CITY PLAN COMMISSION

FILE NUMBER: S245-028

LOCATION: Sycamore Street at North Carroll Avenue, east corner.

REQUEST: An application to create one 0.175-acre (7,619 square feet) lot from a tract of land in City Block 737 on property located on Sycamore Street at North Carroll Avenue, east corner.

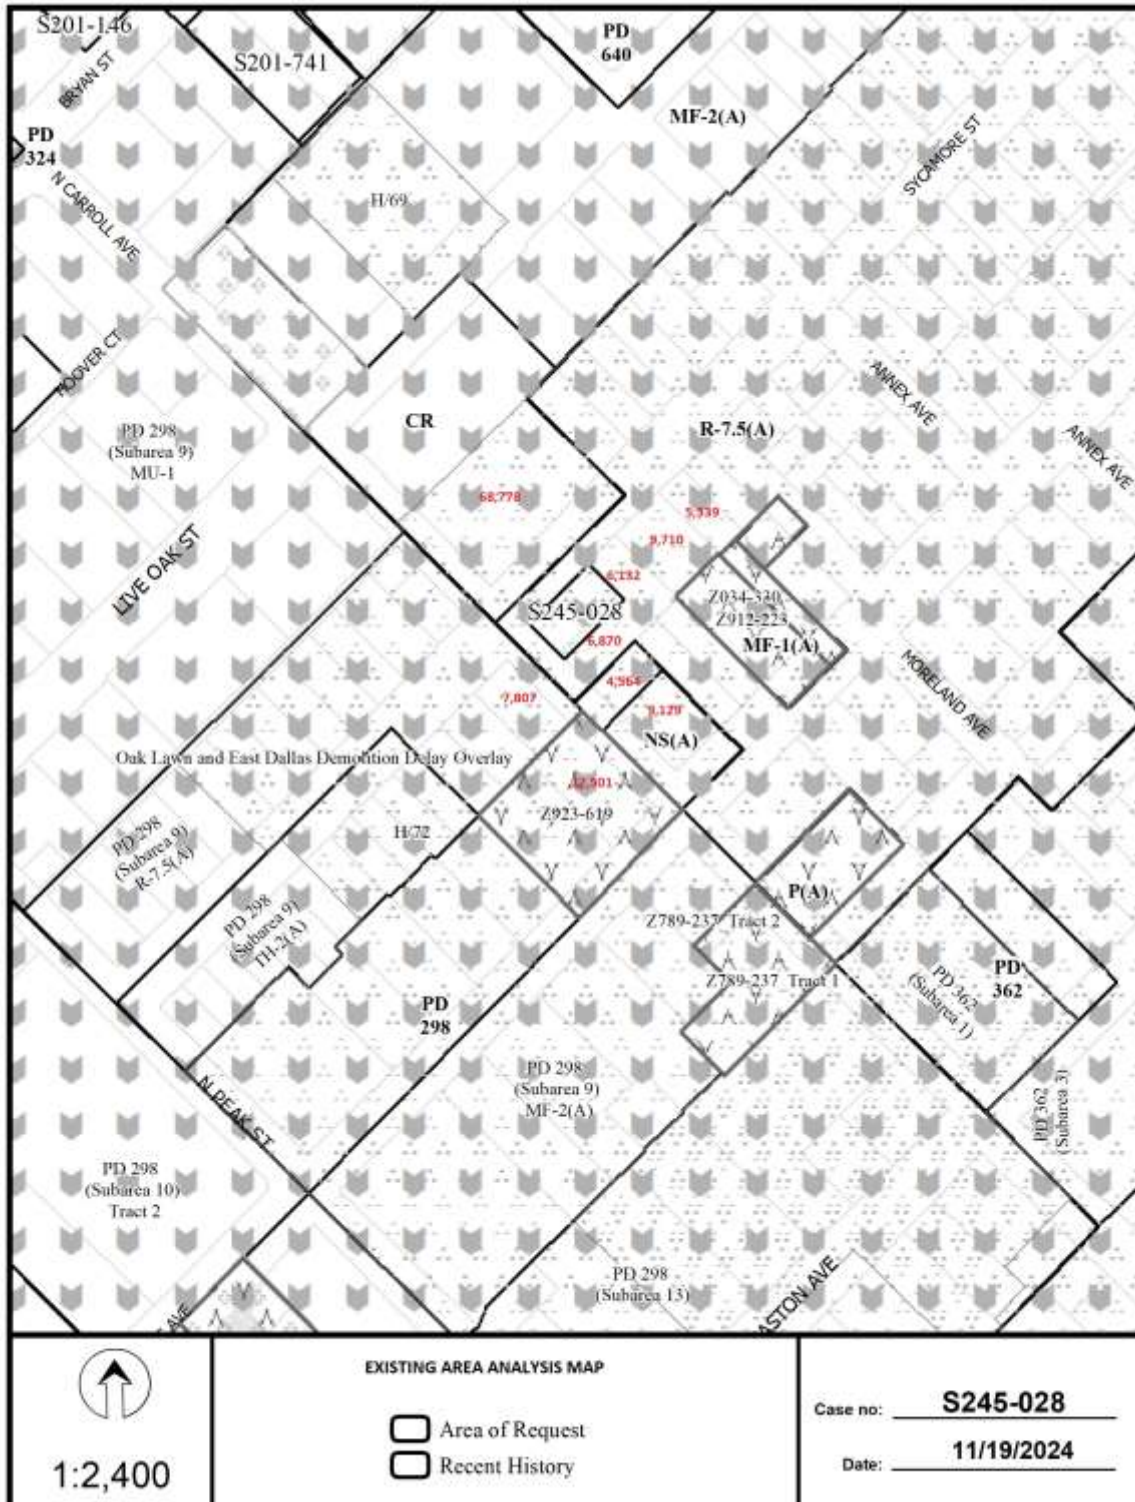
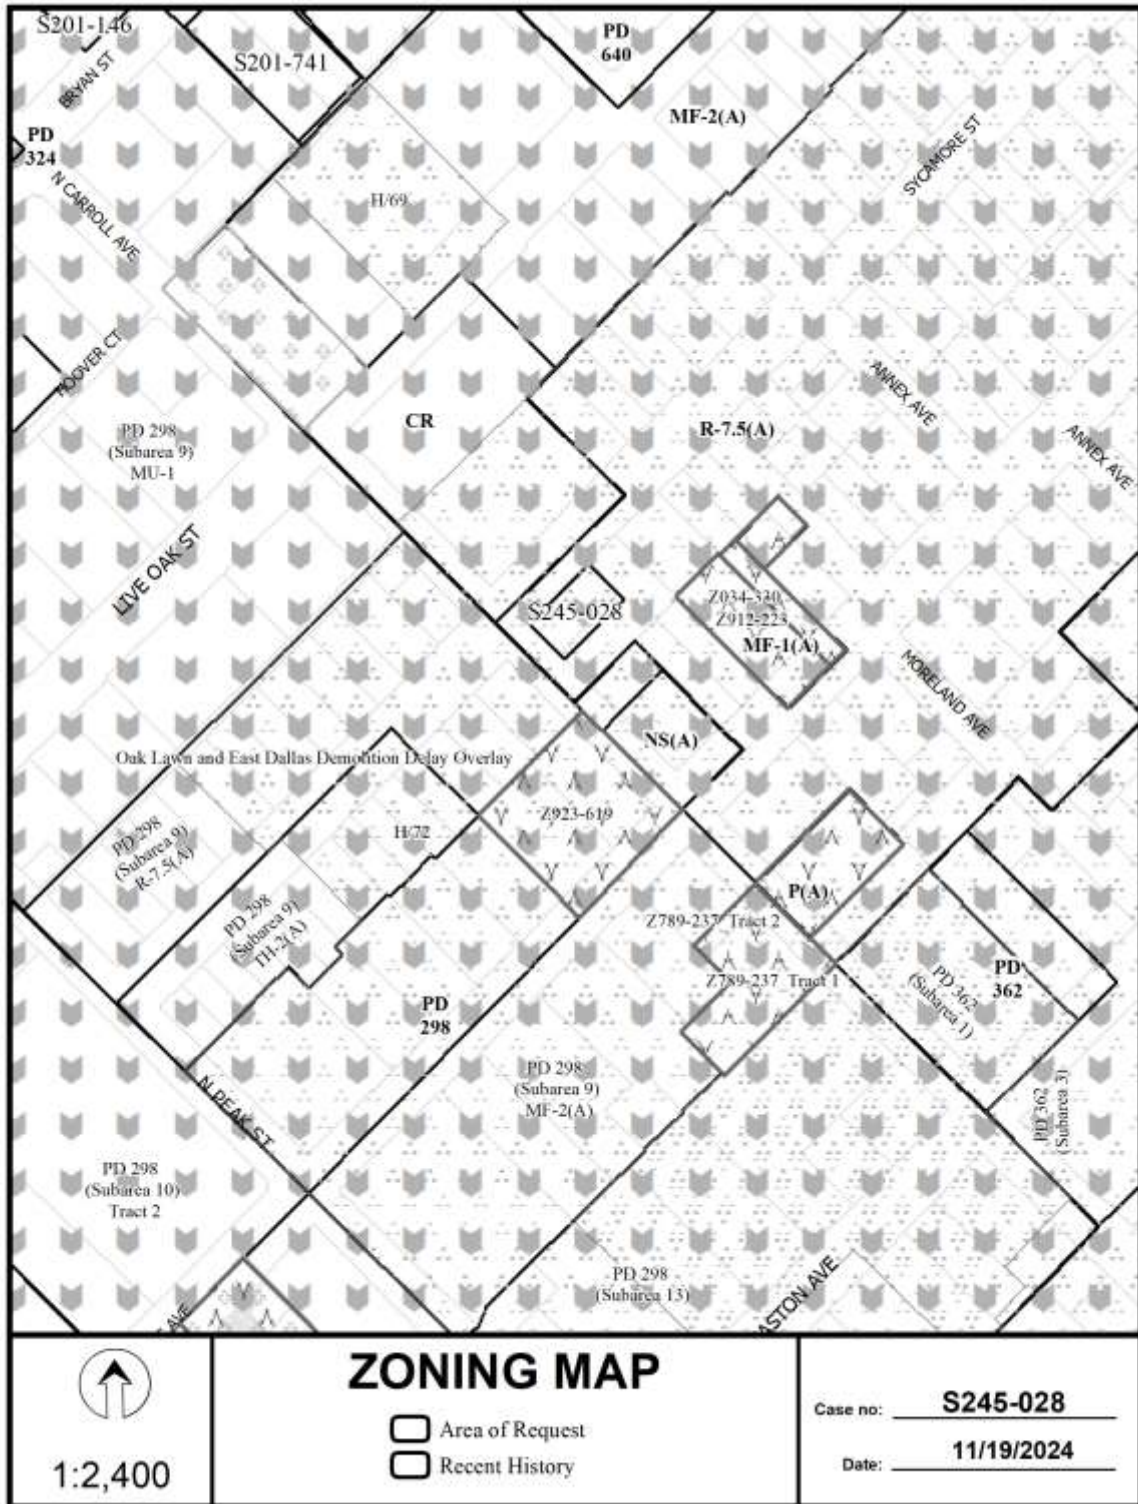
15. On the final plat, dedicate a minimum 5-foot by 5-foot corner clip (via fee simple or street easement) at the intersection of Sycamore Street & Carroll Avenue Section 51A 8.602(d)(1).

21. On the final plat, change “N. Carroll Avenue” to “Carroll Avenue”.
22. Comply with Street Design Manual Section 4.3.3.2(D) and Section 4.4.2.1 regarding required minimum corner clips at intersections.
23. On the final plat, identify the property as Lot 2 in City Block 2/737.
